# Central Coast Local Planning Panel

Central Coast  
LOCAL PLANNING PANEL MEETING  
Business Paper  
22 July 2021

3.1	DA/60262/2020 - 2 Scenic Highway, Terrigal - Ex-HMAS Adelaide Mast at the Terrigal Haven on to a plinth footing with landscaping and provision for a flagpole .....	11

**Figure 4 – Photomontage of proposed development prepared by Leslie Howard Associates, dated 6 November 2020**

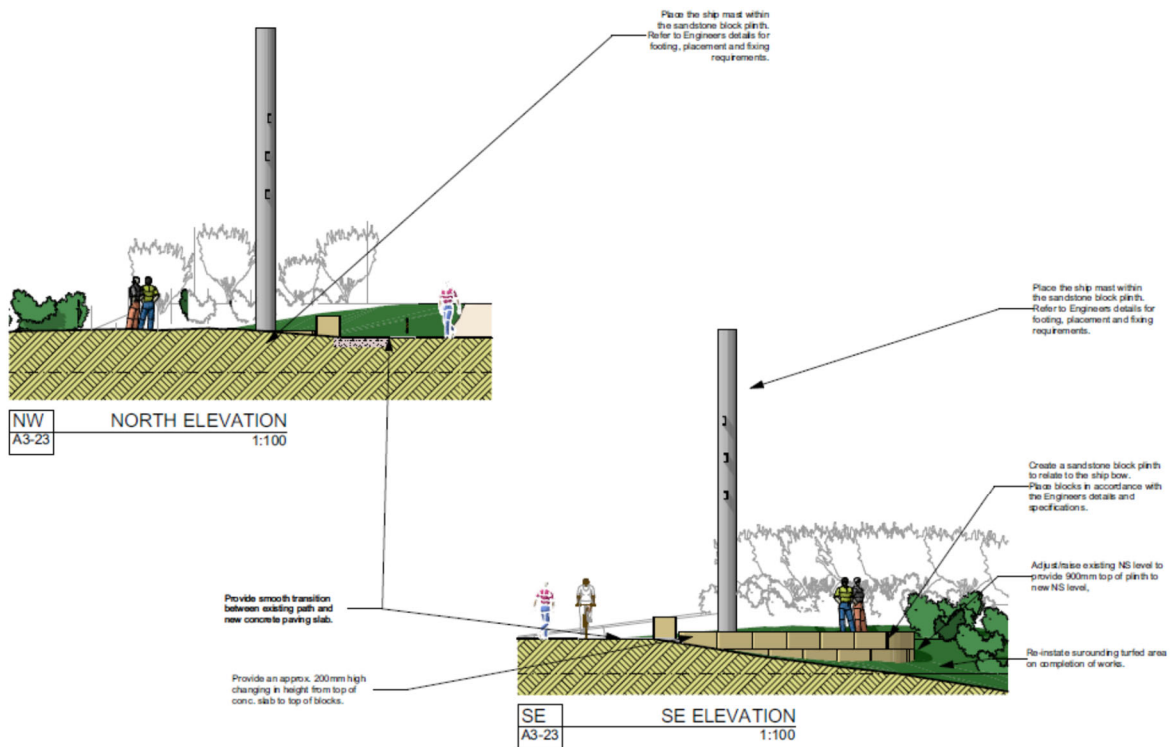
The development application did not include a survey, and amendments requested to architectural drawing package to show correct dimensions of the structure and surrounding area has not been provided. It is further noted that the Statement of Environmental Effects (SEE) states the structure is 7.4 metres, and that the base of the mast will be 2 metres above ground level.

The architectural drawings show the mast height at approximately 9 metres and the Independent Review of the Green Light Visual Impact Assessment states the proposal will be approximately 9.5 metres. Therefore, proper comprehension of the scale of the development is unable to be achieved,

**SITE PLAN**

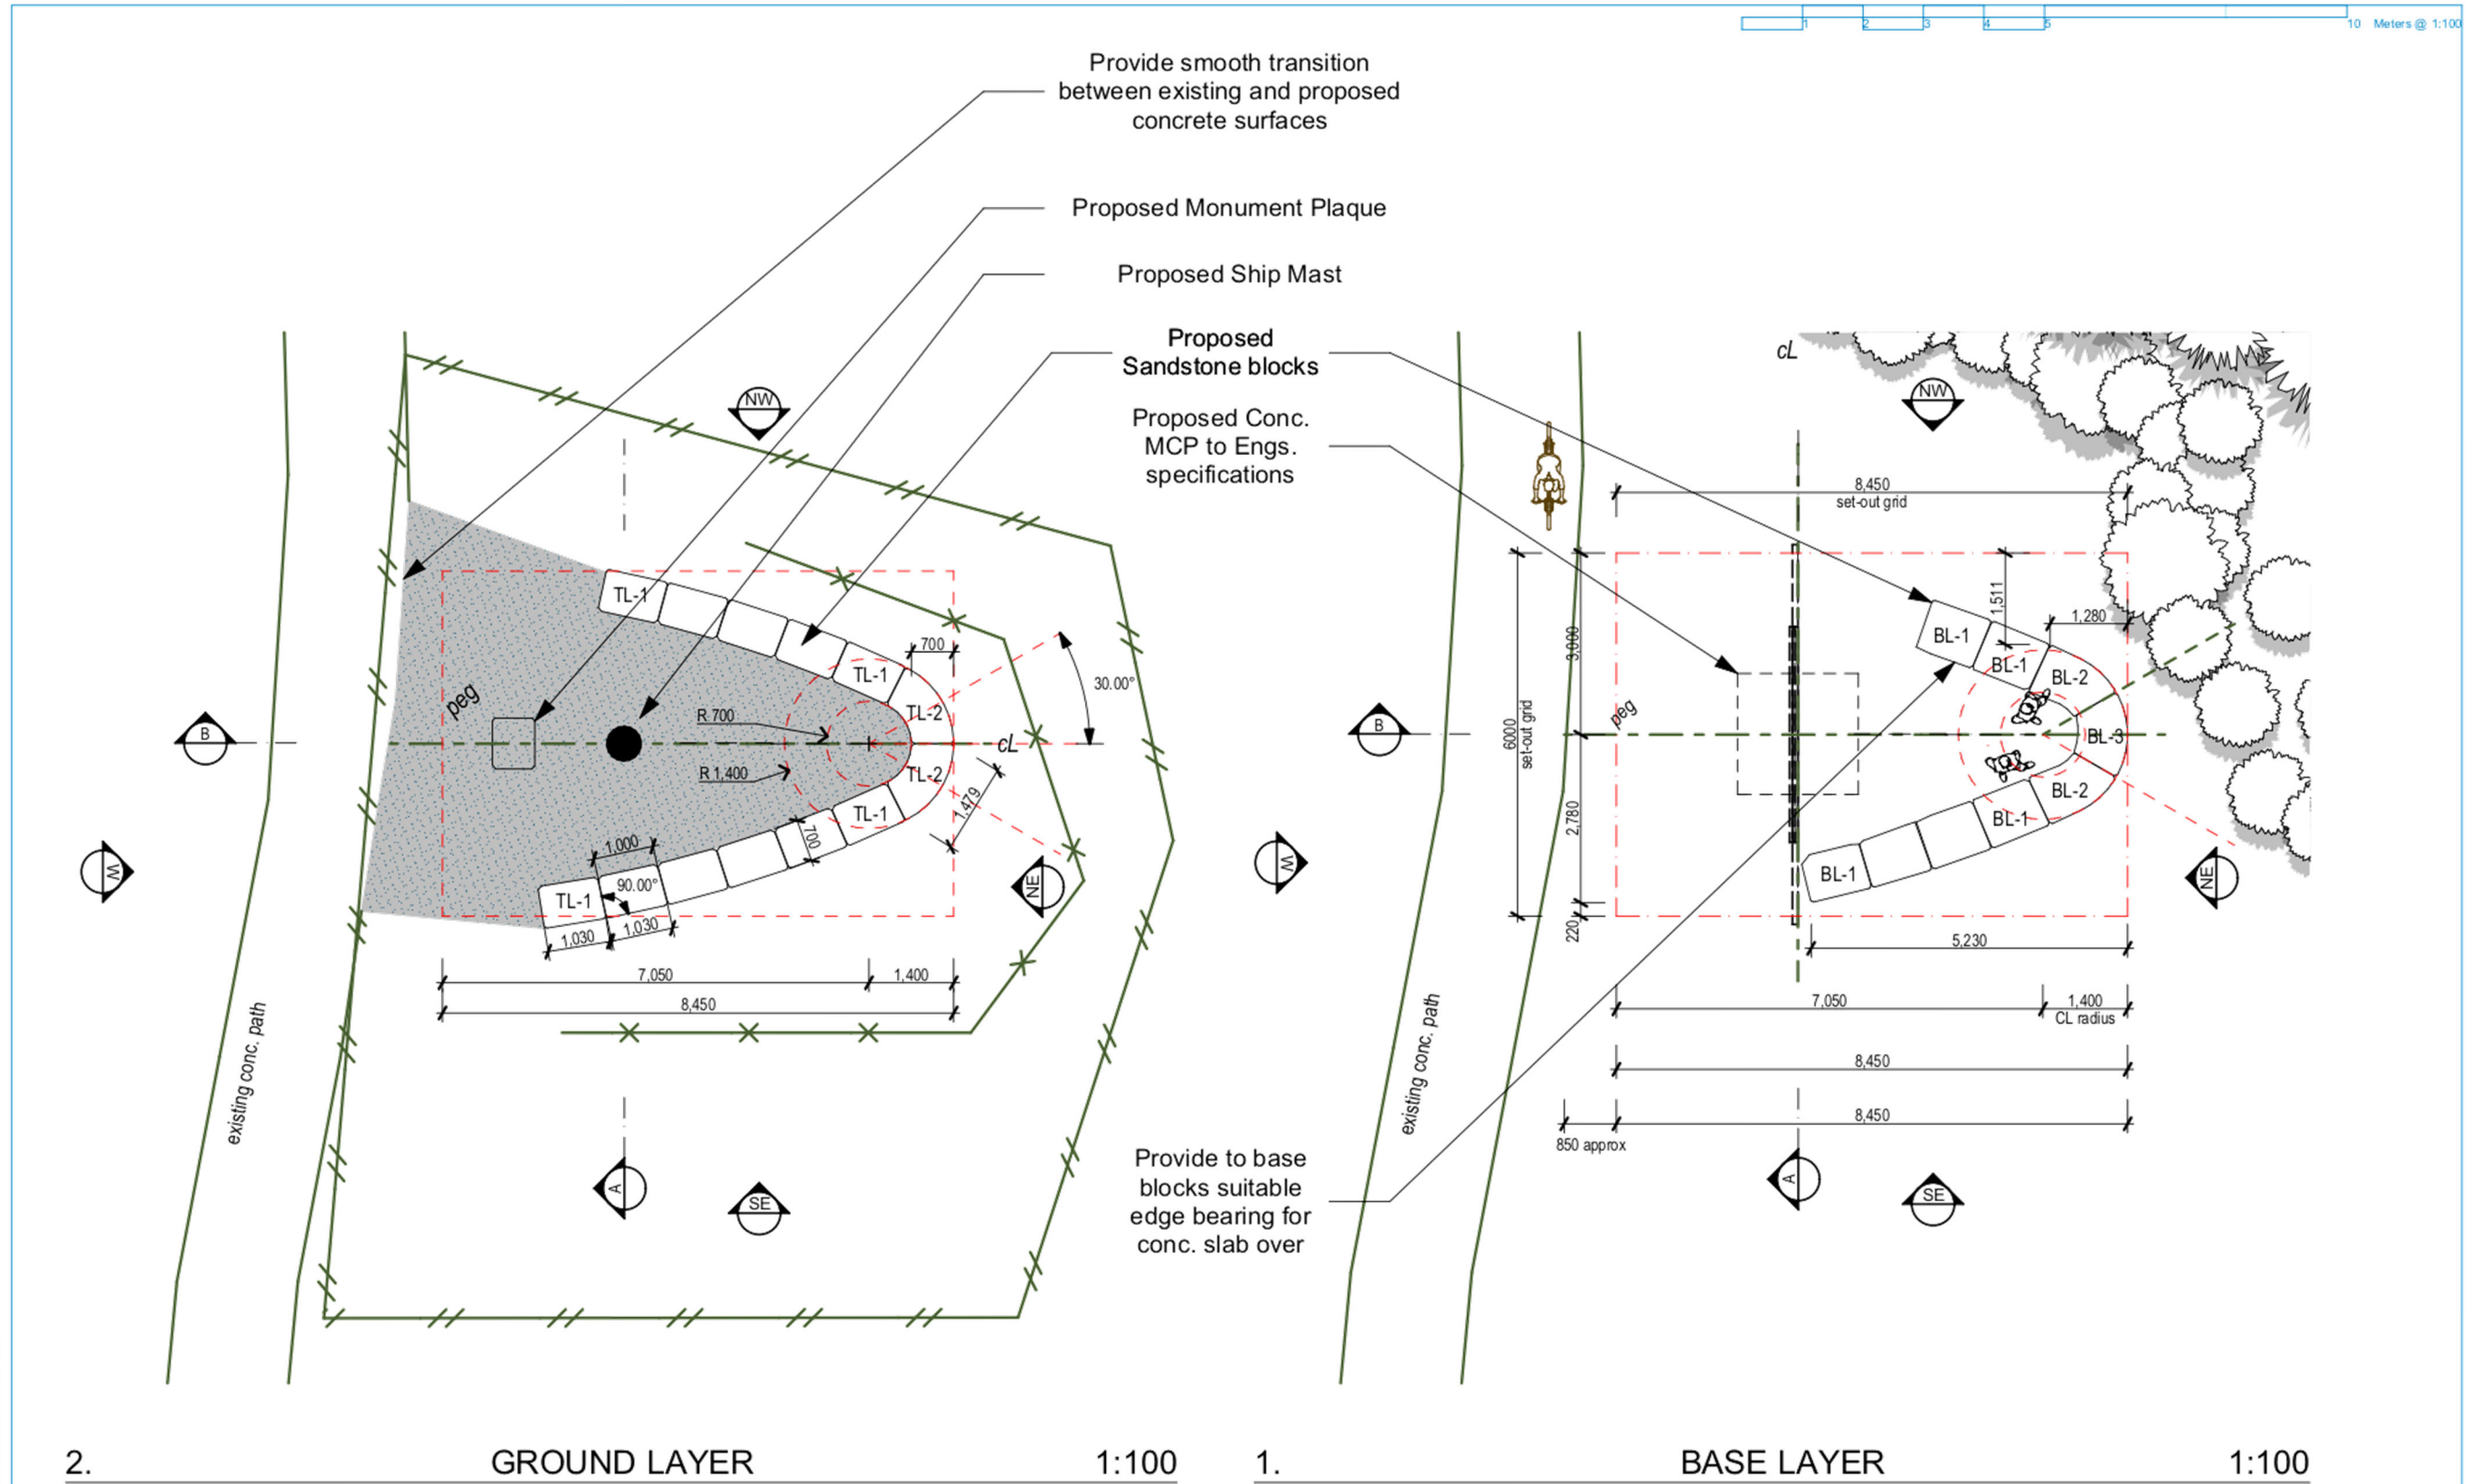
The architectural drawings show landscaping immediately to the north and east of the proposed development which does not appear to be consistent with that in situ. Inadequate information has been submitted regarding the protection of, or proposed removal and rectification of existing landscaping.

Figure 2 - Site 1 Ramp 1

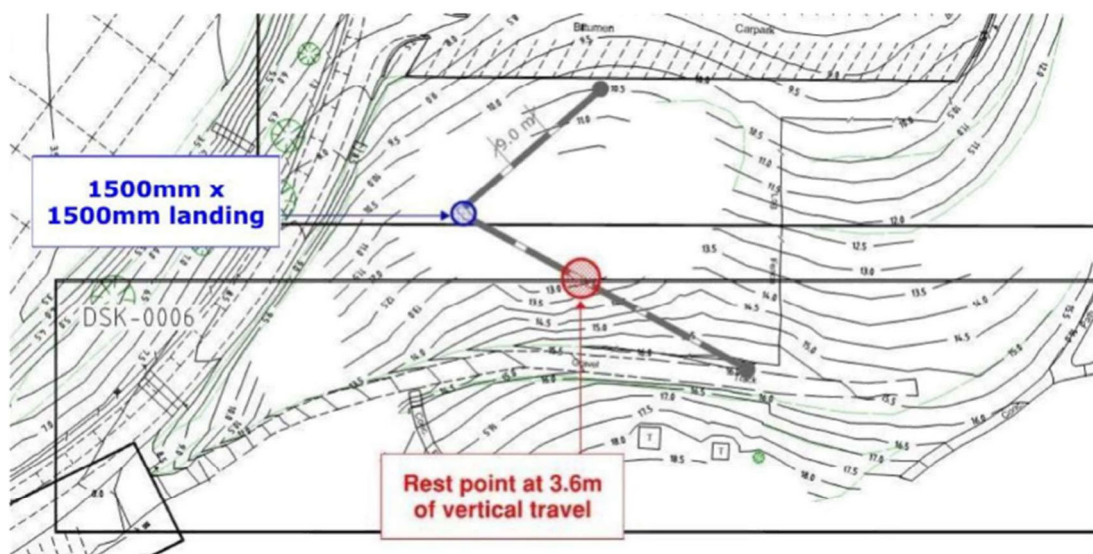
scuttled ship. The Site is currently accessed by a pathway with stairs and is not accessible for many people including wheelchair users, people with children in strollers and others who are unable to use stairs. To make the site accessible it is clearly necessary to provide an alternative to the current pathway.

Provide an accessible path of travel to the Memorial Site that is in accordance with AS1428.2 (1992).

Figure 4 - Site 2 Proposed Ramp Locations

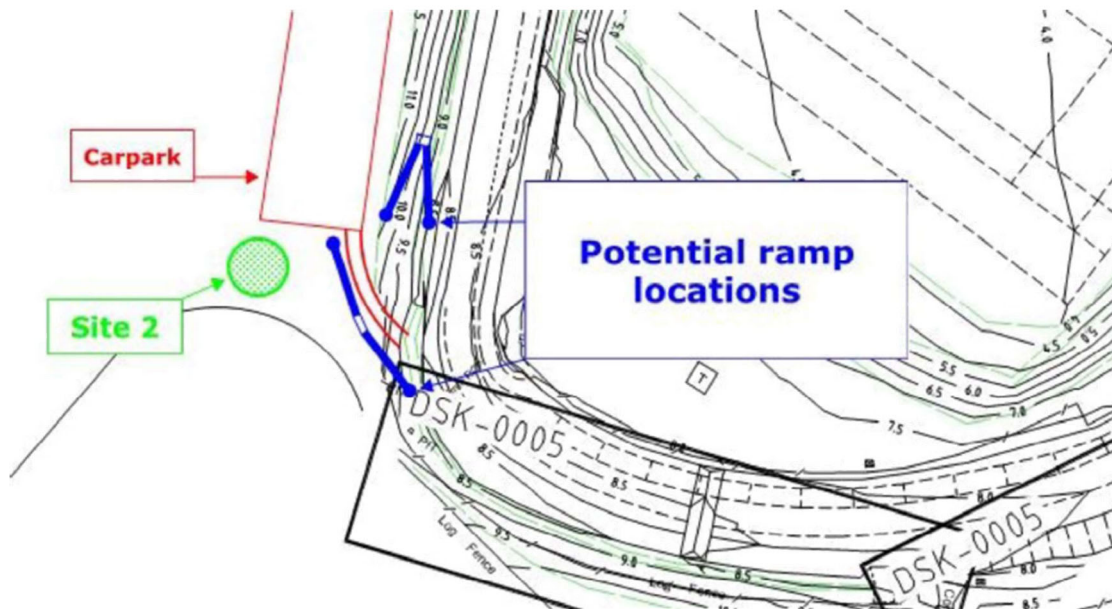
Site 2 has been proposed by objectors to the Development Application as an alternative to the Site proposed by Council. The Site is at the Southwestern corner of the park and directly overlooks the approximate location of the scuttled ship. The area immediately to the North of the proposed position of the lookout could be easily developed to provide accessible parking close to the monument.

Figure 4 details the proposed locations that a ramp could be installed for access from accessible parking to Site 2. Access to Site 2 would require considerably less expenditure than Site 1 as an access ramp would be shorter and would not require sheltered rest areas. The addition of accessible car parking adjacent to this Site would require the provision of additional access points, which would be designed in conjunction with the new ramp and footpaths.
